MEMORANDUM

To: The Design Advisory Board
From: Mary O'Neil, AICP, Principal Planner
RE: ZP18-0455CA/CU 44 Hoover Street
Date: November 14, 2017

File: AP18-0455CA/CU
Location: 44 Hoover Street
Zone: RL **Ward:** 6S
Date application accepted: November 1, 2017
Applicant/ Owner: Andy Greenberg dba 154 Design; Jessica and Alberto Gutierrez
Request: Demolish existing 2 car garage, replace with 2 car garage with accessory dwelling unit.

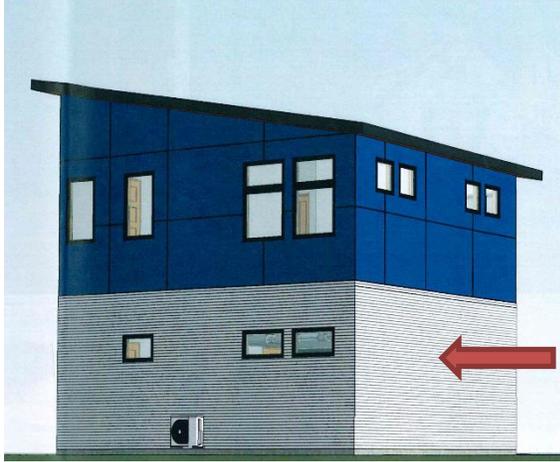
The scale of the proposed building appears to exceed that of the principal residence, which is a 1 ½ story vernacular Craftsman style building. The visibility may be somewhat ameliorated by the recessed location behind the existing home, the increasing grade to the east and the slightly larger residential building immediately adjacent.

The submission documents point to the existence of tall trees acting as a visual buffer to the large building. Given the weather events of the last week, it can be determined that even the largest trees may not endure. Building massing must be assessed for appropriateness based on surrounding structures rather than their likelihood to be shielded by vegetation. At 21'6 ¾" the ridge appears to exceed that of the principal residence. In scale and massing, it is not deferential or subordinate to the principal structure.
